WS Acquisition system, 29 and 30 Nov 2016, Lund

Minutes

Figure 1 Position of the AFE module in the LWU, beam is going from left to right

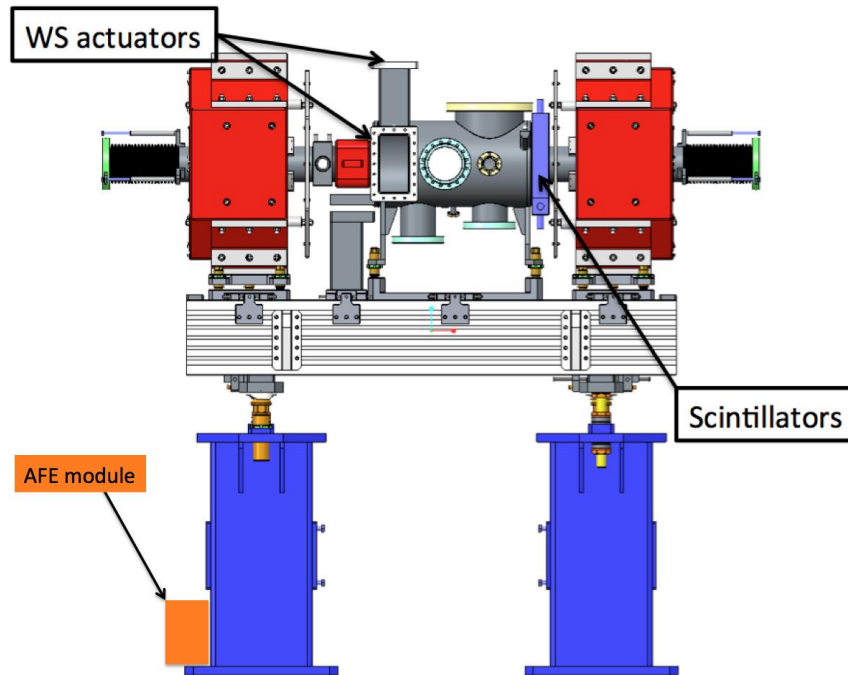
- The WS Analog Front End (AFE) must be install as close as possible to the wire. Radiation maps, downstream the warm linac, have been provided. It has been decide that in the cold linac the AFE module will be installed on the floor close to the LWU support (see Fig. 1), ESS Bilbao will look at a similar solution for the MEBT.
